ADDENDUM 01, DELTA 01

DATE 01.30.2026

PROJECT: Santa Rosa Freestanding Emergency Room

ARCHITECT'S PROJECT NUMBER:
225014.00

TITLE

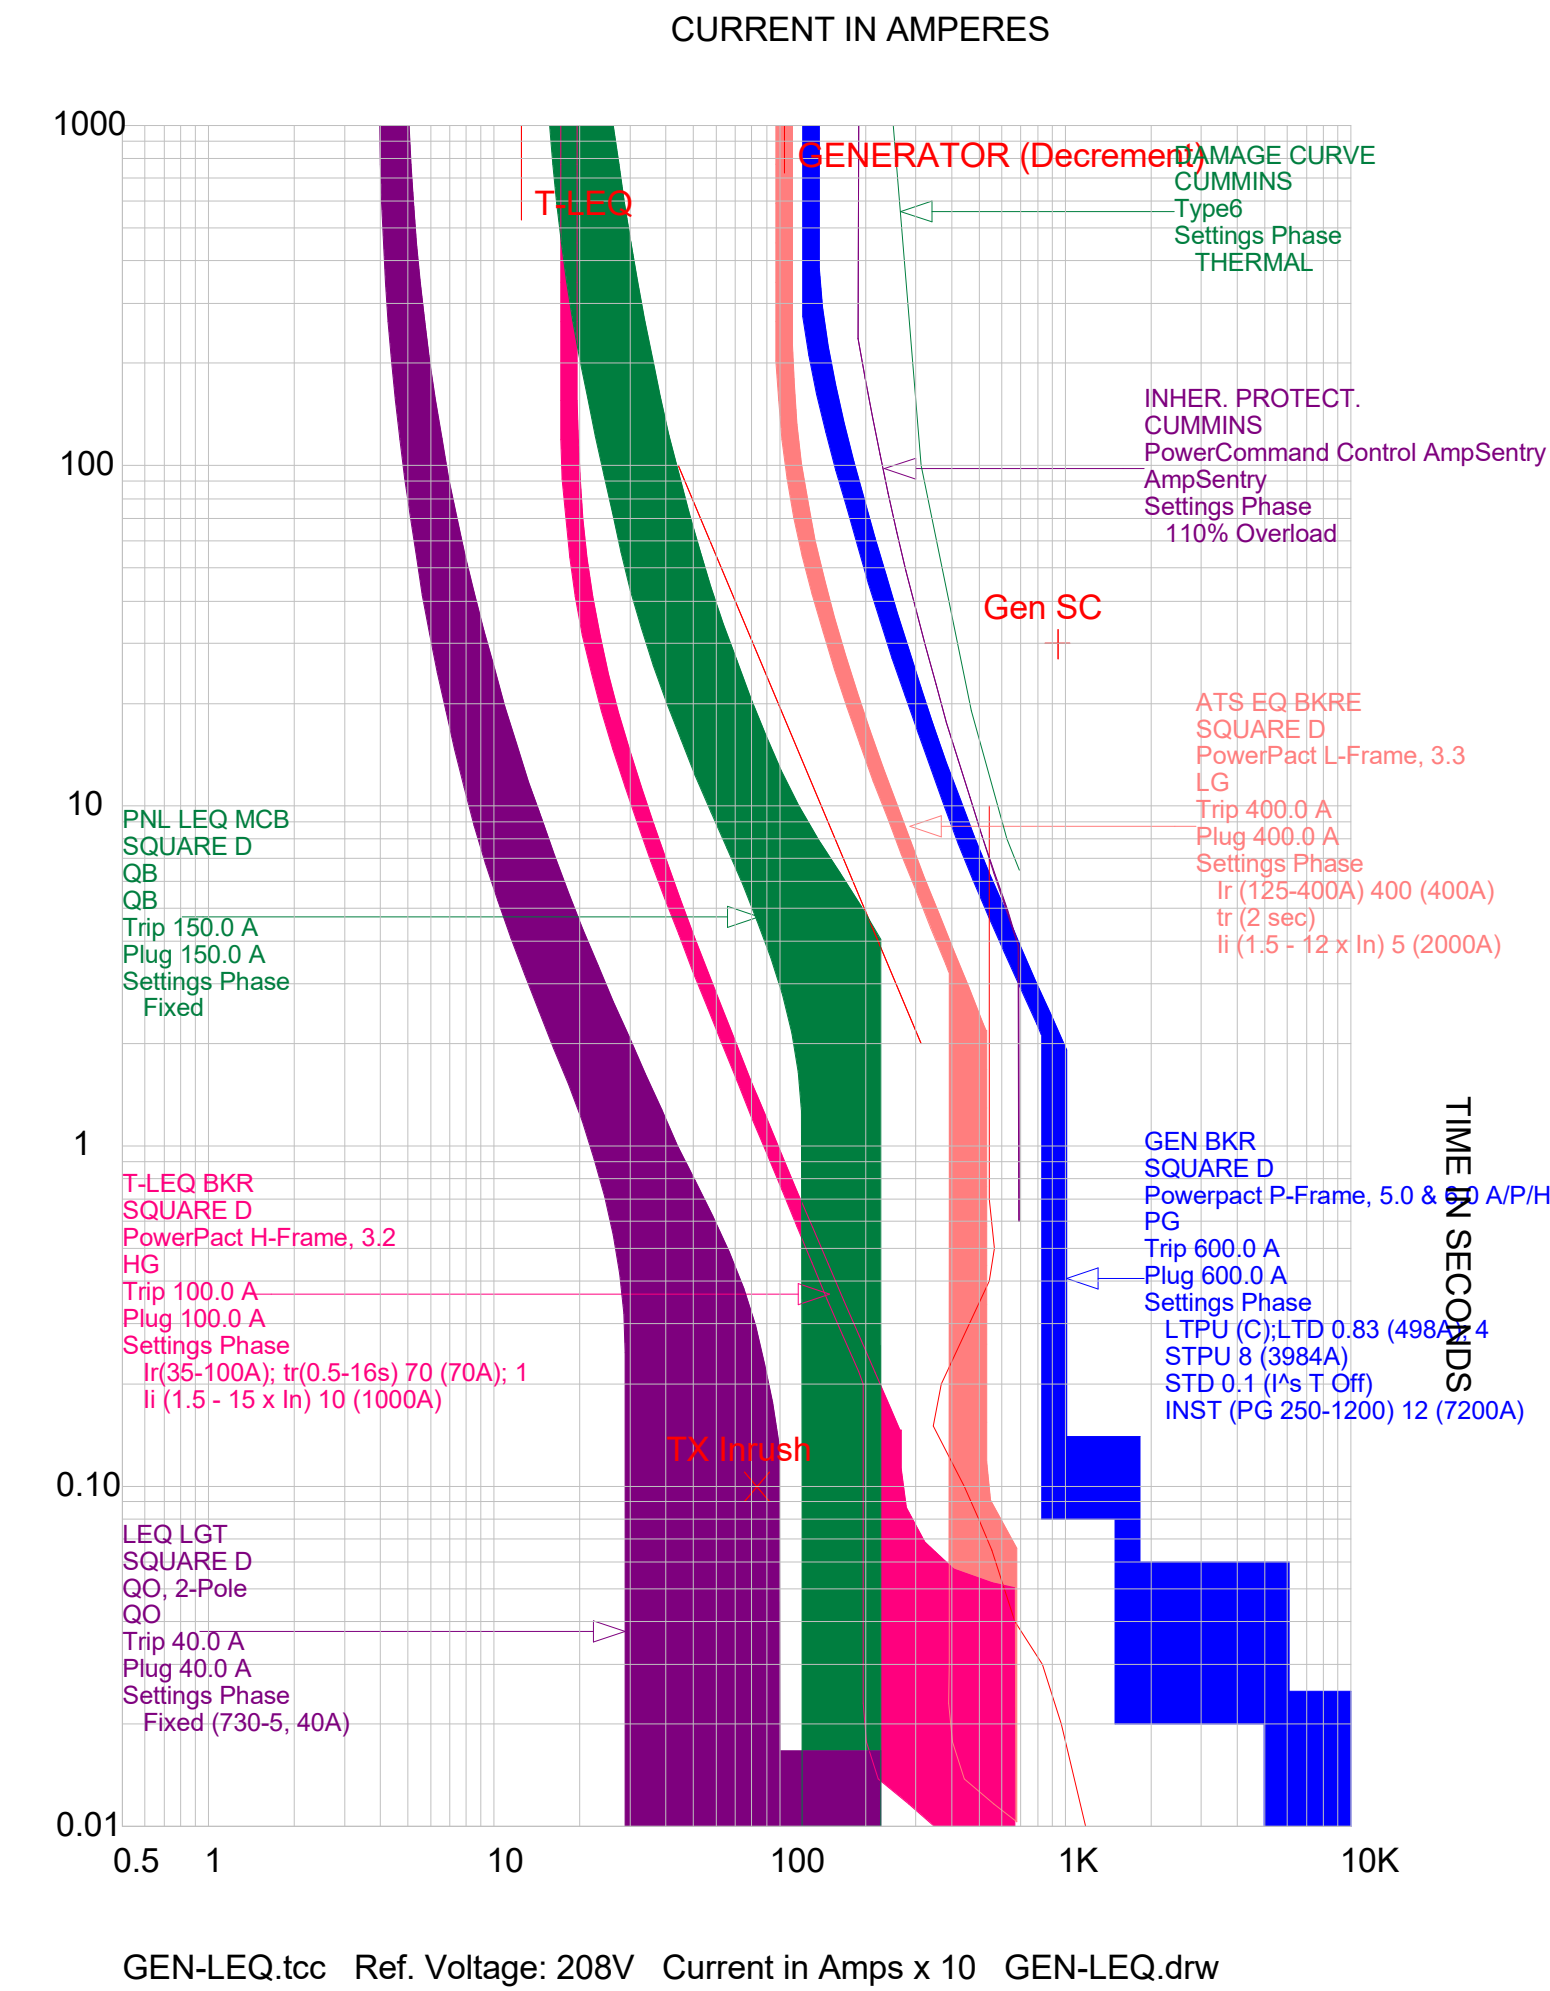
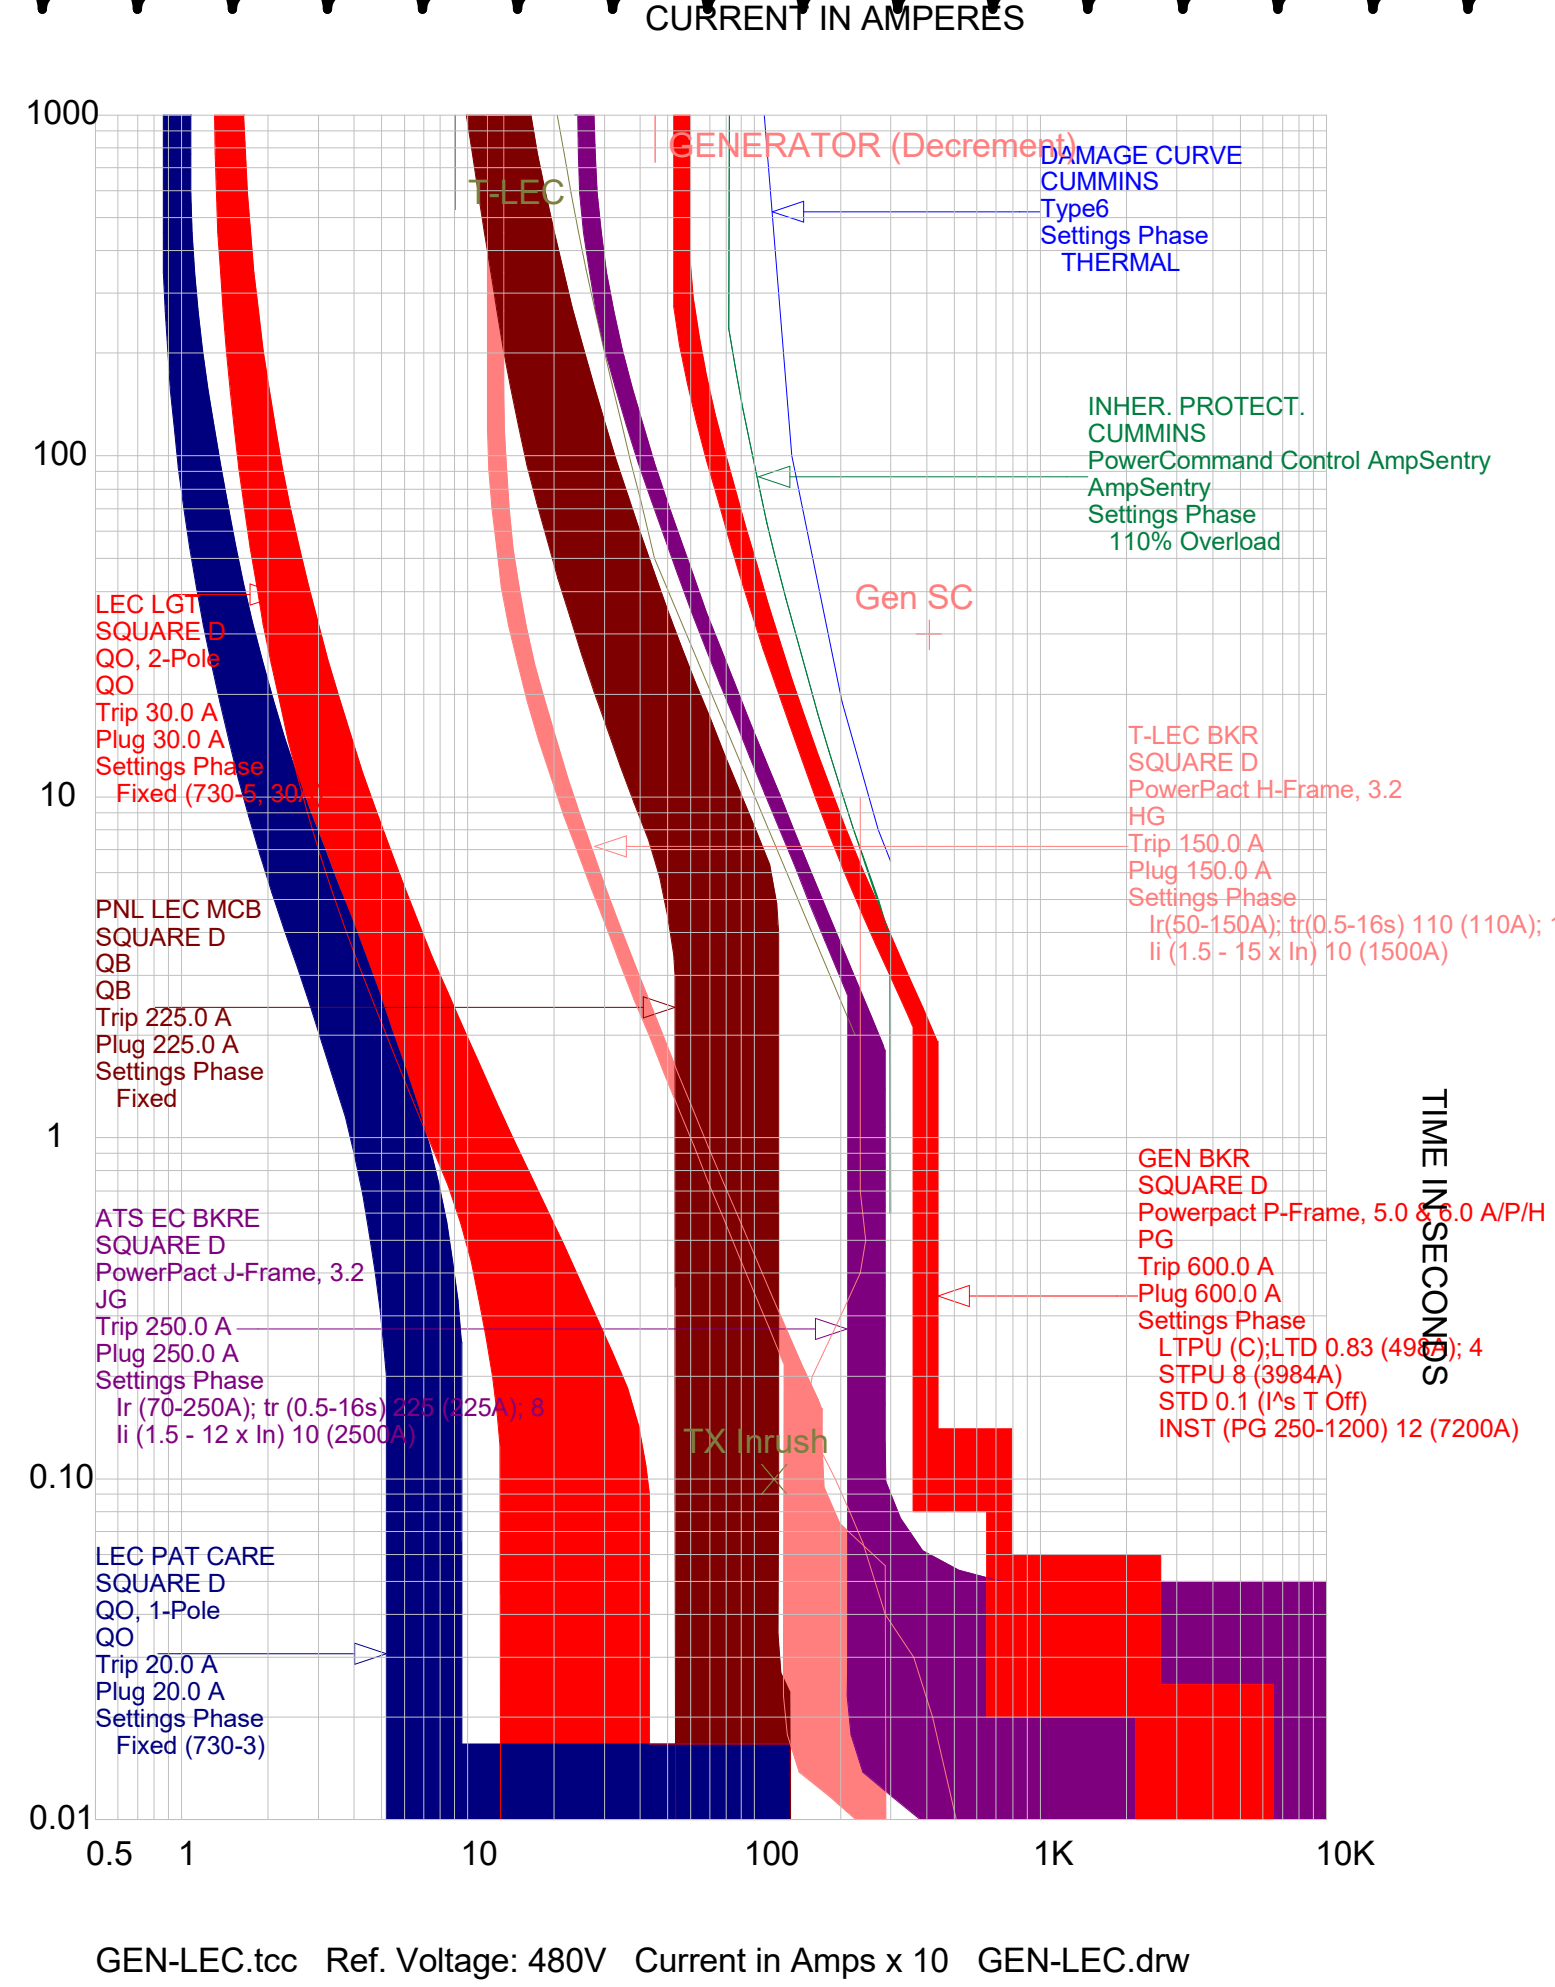
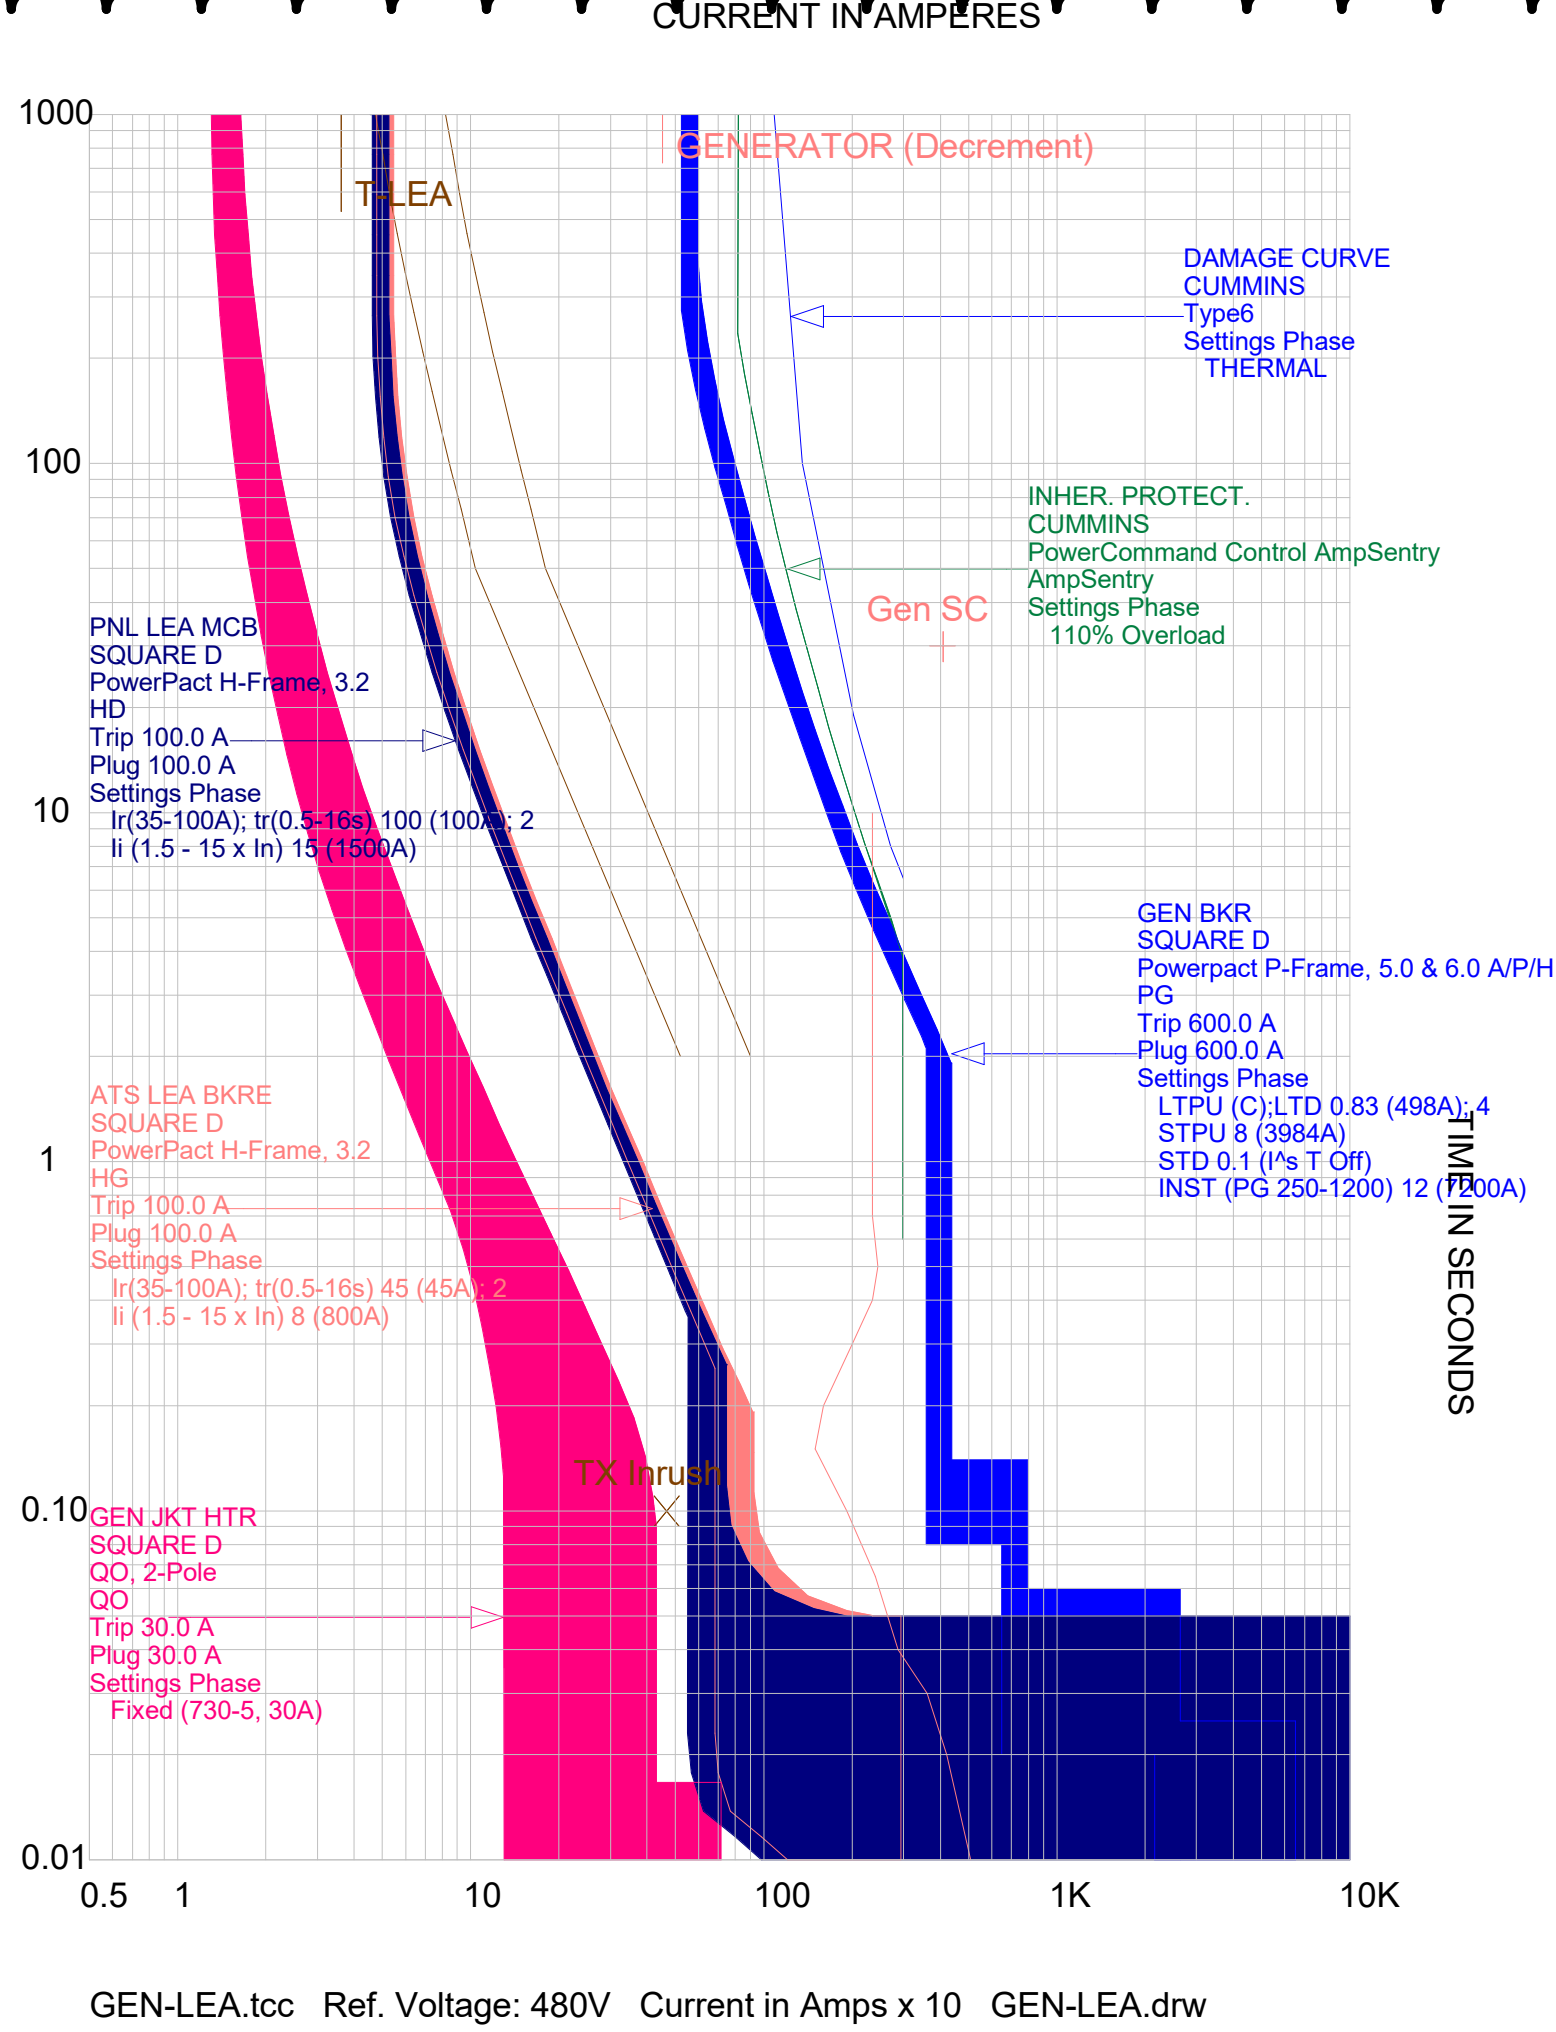
1. Revised the breaker curves to comply with AHCA comments.
